Access Compliance Report

Public Rights-of-Way

(Curb Ramps)

Intersection ID: 11815	Main Street: N_POPLAR_ST	Cross Street: W_7TH_ST	Location: S
ADA ID: 47D6091F8EBE	Ramp Type: PerpDiag	Initial Pass/Fail: Fail	Overall Compliance: No
Severity Score: 25			
Codes/Mitigation Info/Possible Solution		Field Measurements/Component Compliance

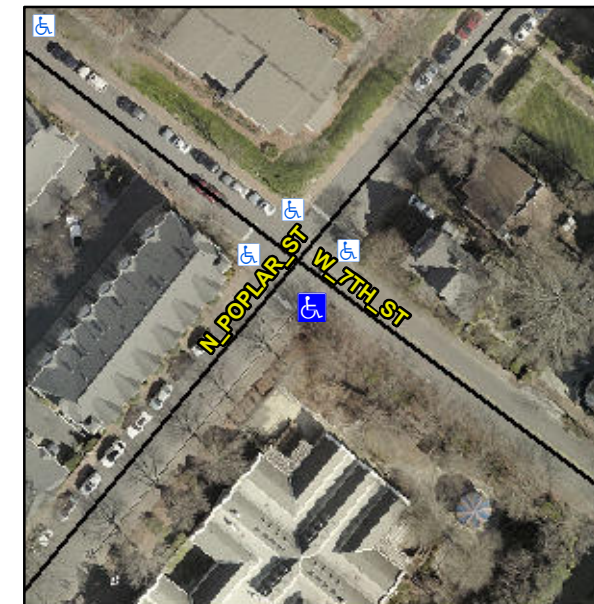
Not Found, R304.2.2, R304.5.3

Compliance	Description	Data	Compliance	Description	Data
N/A	Ramp Length (in)	59.0	No	Ramp Slope (%)	10.7
Yes	Ramp Width (in)	48.0	No	Ramp XSlope (%)	5.8
N/A	Flare Type LT	N/A	N/A	Flare Type RT	N/A
N/A	Flare Slope LT (%)	N/A	N/A	Flare Slope RT (%)	N/A
N/A	Flare Traversable LT?	N/A	N/A	Flare Traversable RT?	N/A
N/A	Landing Length (in)	N/A	N/A	DWS Provided?	N/A
N/A	Landing Width (in)	N/A	N/A	DWS Contrast?	N/A
N/A	Landing Slope (%)	N/A	N/A	DWS Length (in)	N/A
N/A	Landing X Slope (%)	N/A	N/A	DWS Full Width?	N/A
N/A	Landing Curb? (Y/N)	N/A	N/A	DWS Offset (in)	N/A
N/A	Shared Landing?	N/A			
N/A	Gutter Ponding?	N/A	N/A	Gutter Slope (%)	N/A
N/A	Gutter Lip Ht (in)	N/A	N/A	Gutter X Slope (%)	N/A
N/A	Painted X Walk1?	No	N/A	Painted X Walk2?	No
	X Walk 1 Direction	To NE		X Walk 2 Direction	To NW
N/A	X Walk 1 Width (in)	N/A	N/A	X Walk 2 Width (in)	N/A
	X Walk 1 Slope (%)	3.2		X Walk 2 Slope (%)	0.4
	X Walk 1 X Slope (%)	0.7		X Walk 2 X Slope (%)	2.3

Remove & Replace Curb Ramp With Two New Directional Ramps or Equivalent.
